**DIVISION OF WATER RIGHTS
REPORT OF COMPLIANCE INSPECTION**

APPLICATION: 26224

PERMIT: 20035

LICENSE: 12831

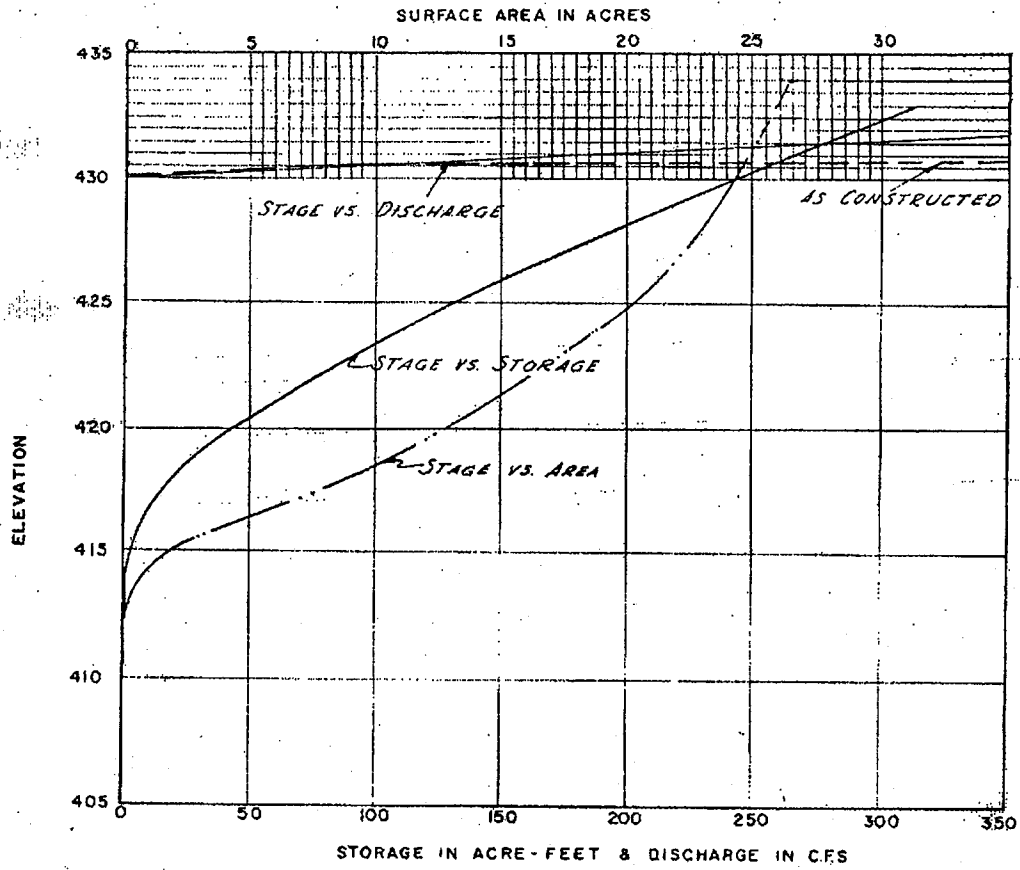
At the time of the inspection the lake was at the level of the spillway and spilling at a rate visually estimated to be under 0.1 cfs. The manager indicated that the lake level normally dropped about 4 feet maximum between the diversion seasons. He said that the lake was full by the end of January and normally filled without the use of diversions from Oak Flat Creek. Oak Flat Creek diversions usually begin at the end of March and continue to the end of the diversion season on May 31. According to the manager, the Oak Flat Creek diversion is used only to keep the lake full by replacing evaporation and seepage. If the diversion pipe flows at 60 gallons per minute for the typical time of two months, the amount taken from Oak Flat Creek would be about 16 acre-feet, some of which replaces evaporation and seepage and some may spill as observed during the inspection. This is less than average evaporation during April and May (about 22 ac-ft).

Based on the area capacity curve of the reservoir, a drawdown of 4 feet equals a withdrawal of 92 acre-feet. Average class A pan evaporation data is available for Geyserville from Bulletin 113-3. From October 1 to January 31 the total average evaporation is 7.61 inches and from February 1 to May 31 the amount is 25.68 inches. Assuming an average surface area during refill of 20 acres, evaporation of 7.61 inches is 12.7 ac-ft. When the reservoir is full (25 acre surface area) the evaporation from February 1 to May 31 would be about 53.5 ac-ft. **Therefore the total amount of water taken would be the refill of 92 acre-feet plus the evaporation of about 66 acre-feet for a total of 158 acre-feet.**
